# REGULATORY INFORMATION DISTRIBUTION SYSTEM (RIDS)

SUBJECT: Forwards marked-up FSAR & lessons learned implementation  
 rept, reflecting

Subject: Palo Verde Nuclear Generating Station (PVNGS)  
Units 1, 2, and 3  
Post Accident Sampling System  
Docket Nos. STN-50-528(License No. NPF-41)/529/530  
File: 85-056-026; G.1.01.10

Attached for your review and approval are the marked up pages of the PVNGS Final Safety Analysis Report and Lessons Learned Implementation Report reflecting the PVNGS grab sample type post accident sampling system.

Figure 9.3-2A

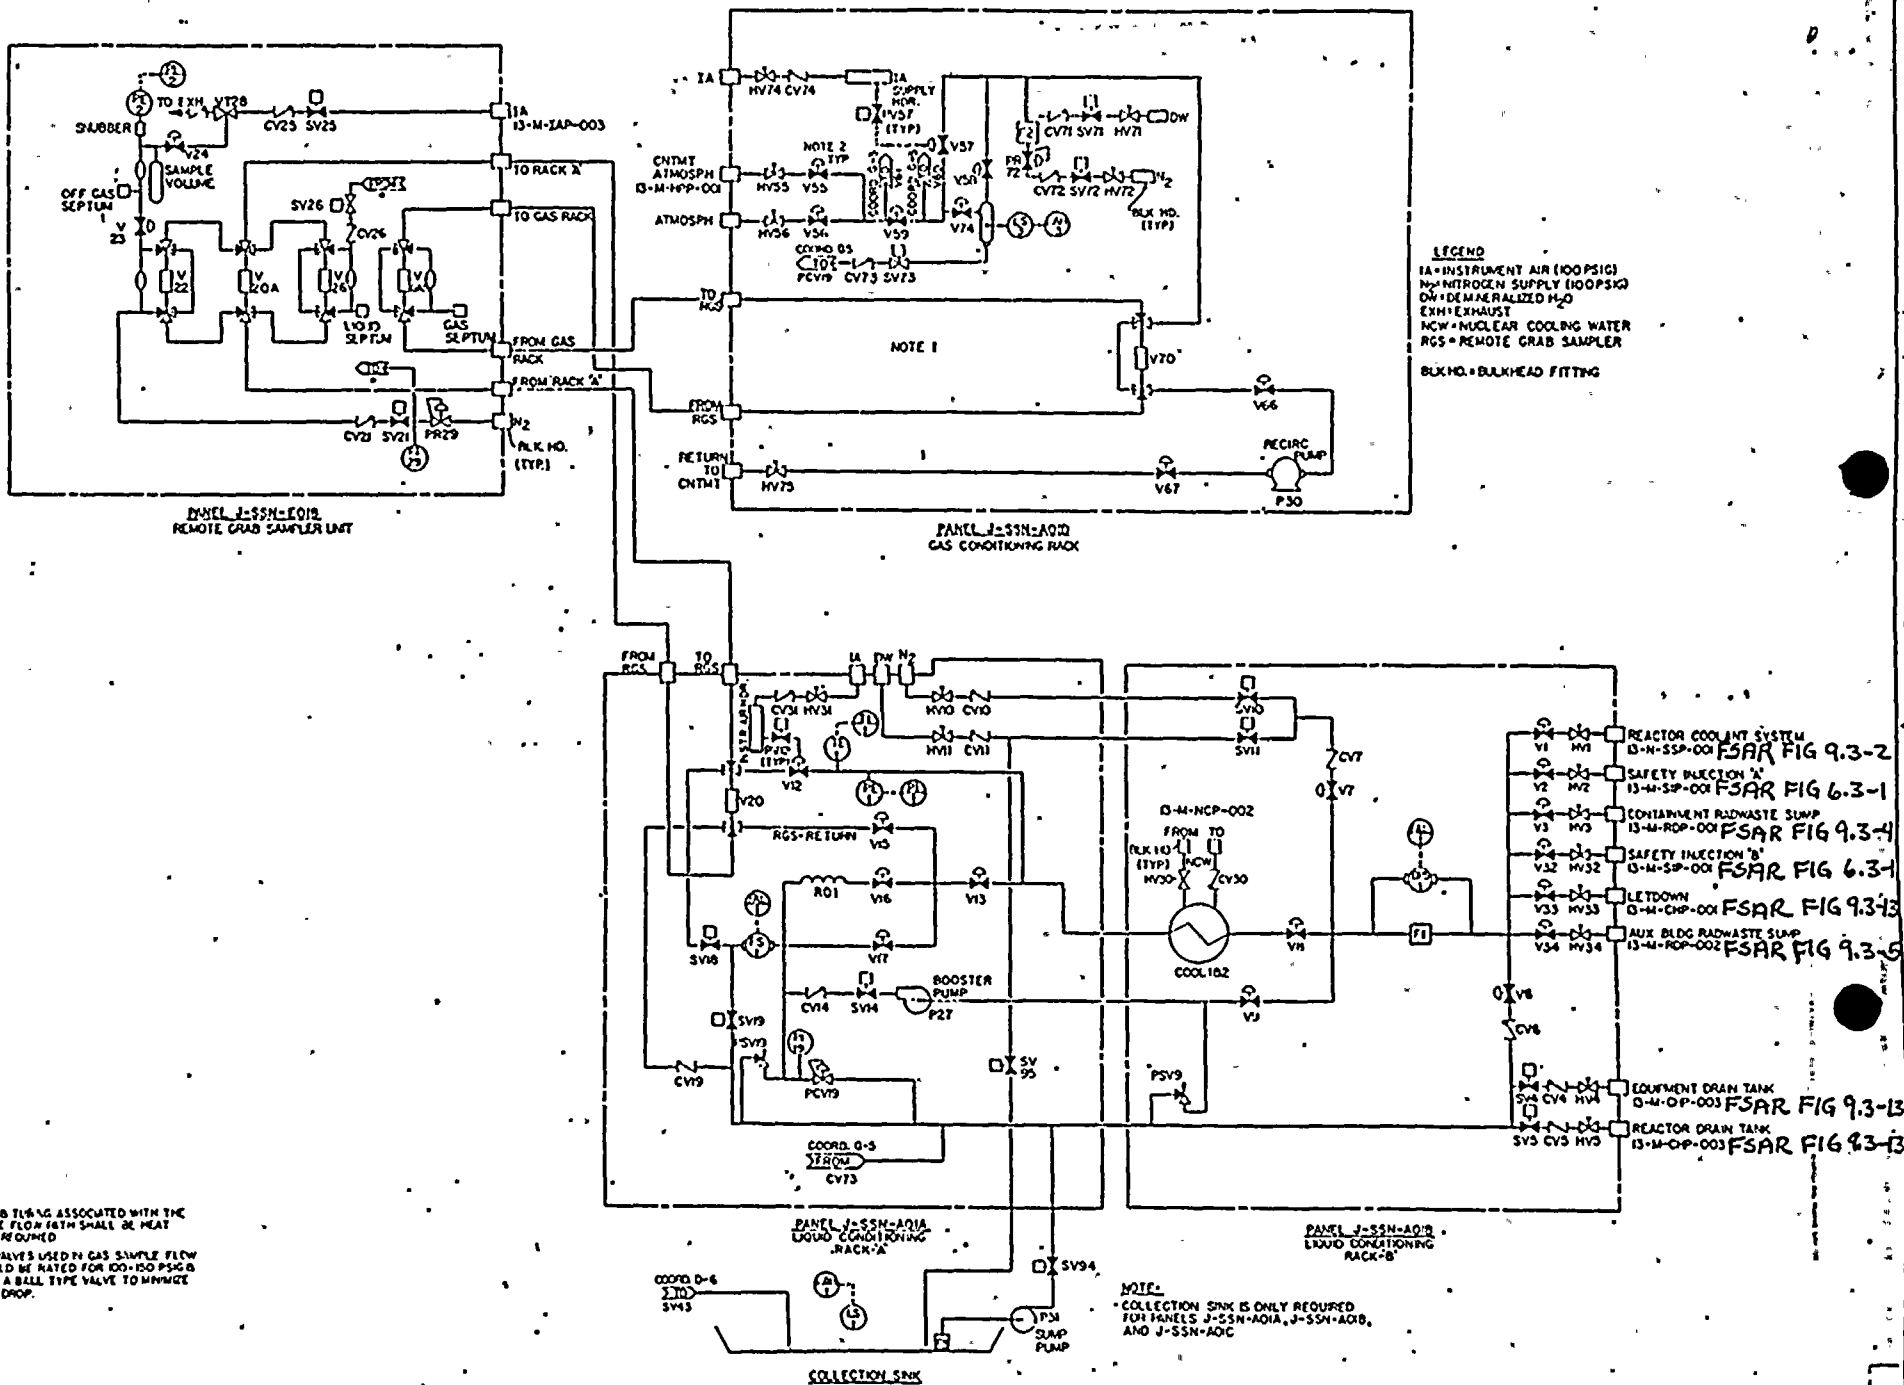
The Post-Accident Sampling System (PASS) for PVNGS will use grab sample methodology as its primary means of sampling reactor coolant and containment atmosphere to meet the requirements of NUREG-0737 ITEM II.B.3. Sample analyses will be performed by laboratory analysis by approved procedures in an appropriate laboratory facility. The PASS can be operated from the hot lab to obtain reactor coolant and containment atmosphere samples and does not require an isolated auxiliary system to be placed into service to obtain these samples. The capability exists to sample and analyze any required sample within the required time span (per NUREG-0737, II.B.3) from the time a decision is made to take a sample.

PASS consists of the following: sample conditioning racks, control panels, electrical interface panels, remote grab sample station. Refer to FSAR Figure 9.3-3A. The PASS equipment includes, heat exchangers, pumps, valves, piping and instrumentation necessary to obtain grab samples. The sample conditioning equipment is located on the 70 foot elevation of the auxiliary building and the remote grab sample station is located on the 140 foot elevation of the auxiliary building. The entire PASS can be operated from the hot lab to reduce operator exposure. All equipment necessary to obtain reactor coolant and containment atmosphere samples, including valves, piping, cabling, motors and instrumentation has been verified to be operable in the environment it would experienced under accident conditions. A manually loaded Class IE power source can be available within 30 minutes of an accident that assumes a loss of offsite power to allow the acquisition of reactor coolant and containment atmosphere samples.

PASS has been designed so that liquid samples can be taken from the RCS hot leg, letdown line, containment radwaste sump, auxiliary building radwaste sumps and the Trains A and B Safety Injection mini-flow line. All samples are routed to a liquid input header. After sample selection, the sample is depressurized and cooled to allow a grab sample to be taken. At this point, a syringe grab sample can be taken, or the sample can be discharged to the reactor drain tank or equipment drain tank. After obtaining the grab sample, the source is isolated, and the system is then flushed with demineralized water, and purged with nitrogen gas.

NUCLEON SAMPLING SYSTEM  
Figure II.B.3-1

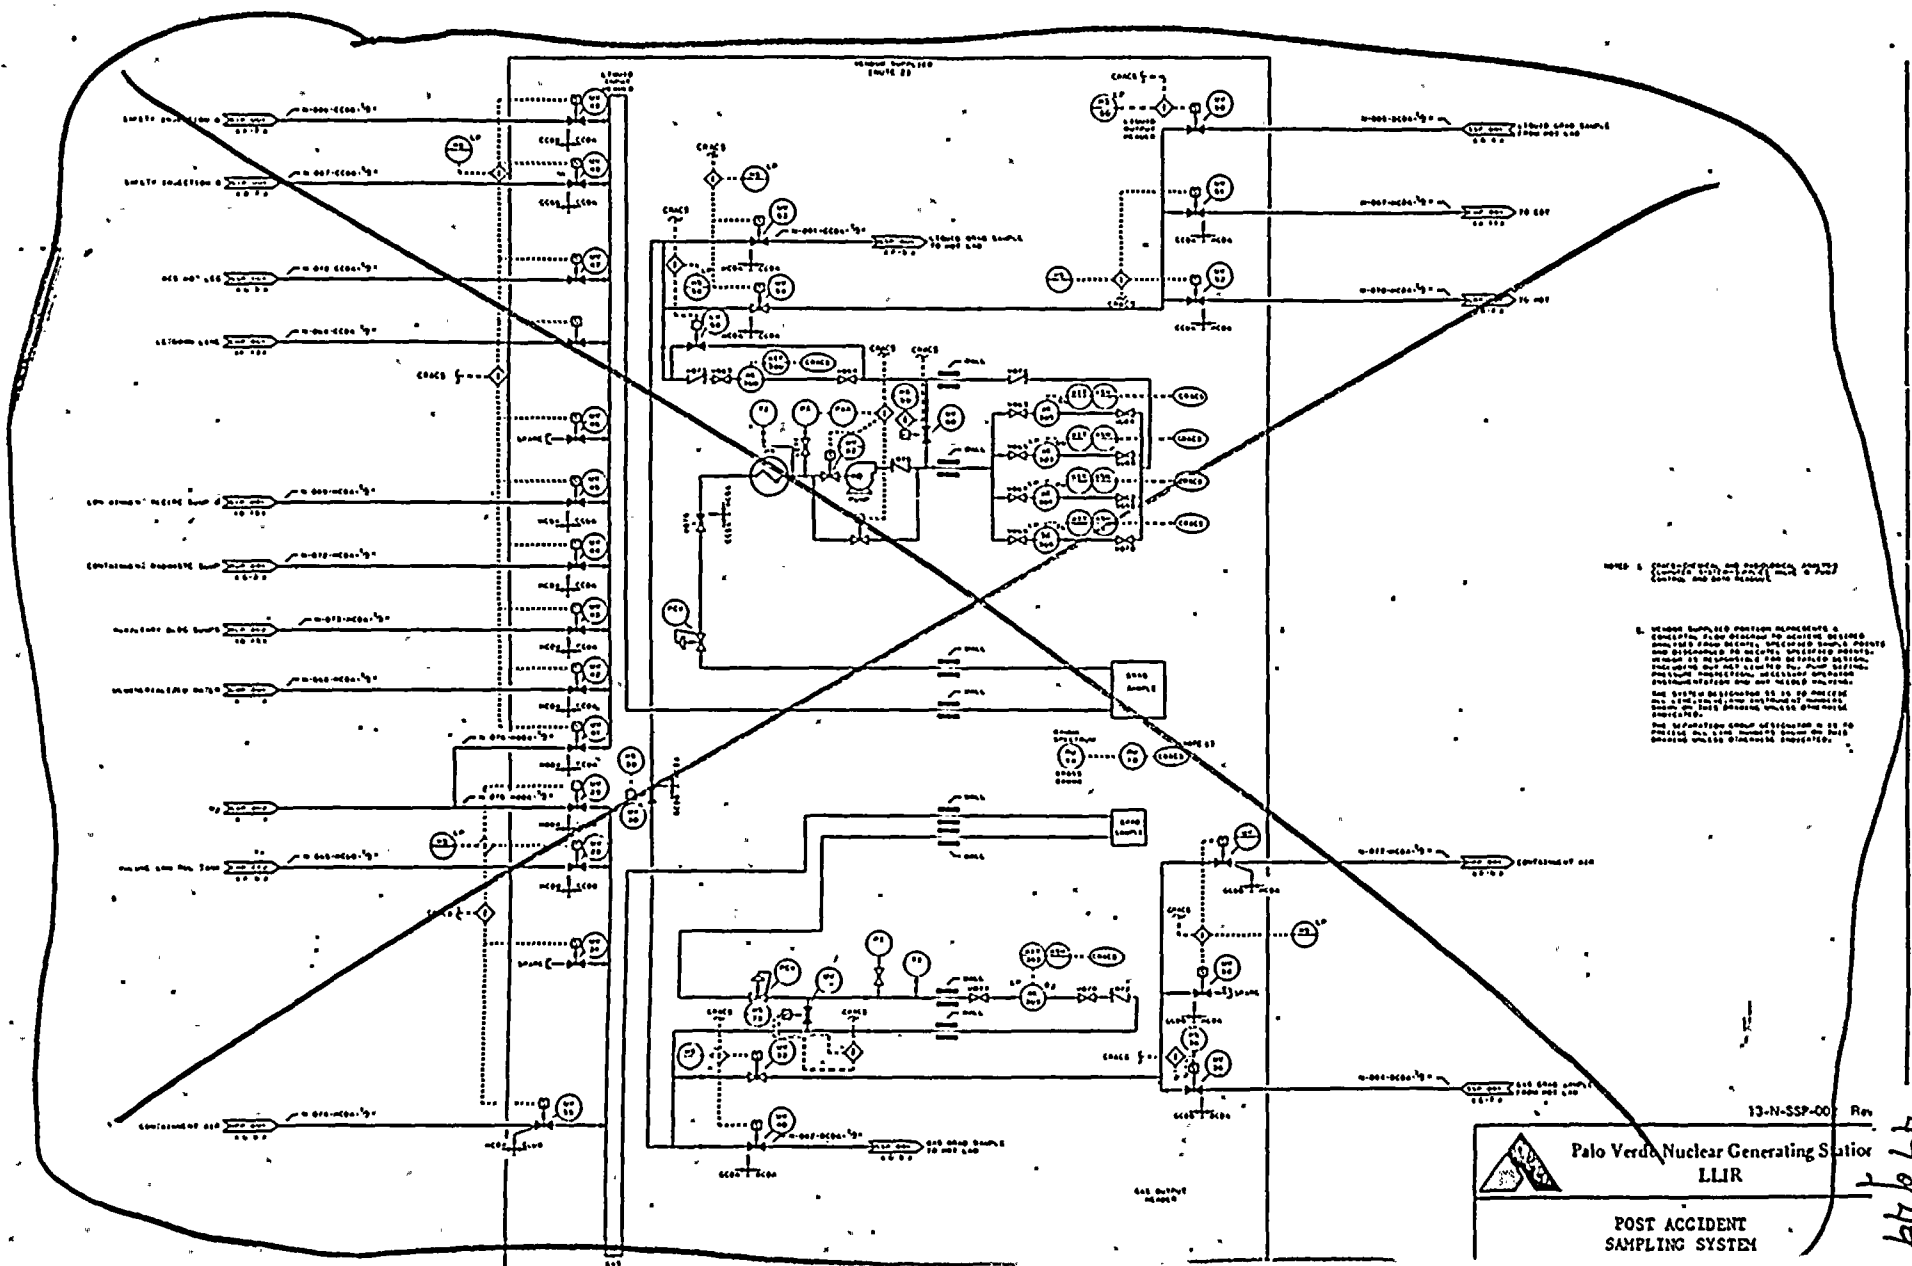
To provide sampling capability with exposures kept ALARA, PVNGS will incorporate a ~~remote, automated, post-accident sampling~~ system that meets the requirements of NUREG 0737, <sup>the guidelines of</sup> and Regulatory Guide 1.97, Revision 2 <sup>as described in Section 9.3.2 and LLIR ITEM II.B.3.</sup> ~~This system can be operated from the radiochemistry counting room, the control room, or the technical support center. Backup grab sample capability will be provided in the hot lab sample room using microchemistry techniques to keep the volume of source as small as possible.~~

To provide sampling capability with exposures kept ALARA, PVNGS will incorporate a ~~remote, automated,~~ post-accident sampling system that meets the requirements of NUREG 0737 ~~the guidelines of~~ <sup>as described in Section 9.3.2 and LLIR ITEM II.B.3.</sup> and Regulatory Guide 1.97, Revision 2. ~~This system can be operated from the radiochemistry counting room, the control room, or the technical support center. Backup grab sample capability will be provided in the hot lab sample room using microchemistry techniques to keep the volume of source as small as possible. Refer to section II.B.3 for further details.~~
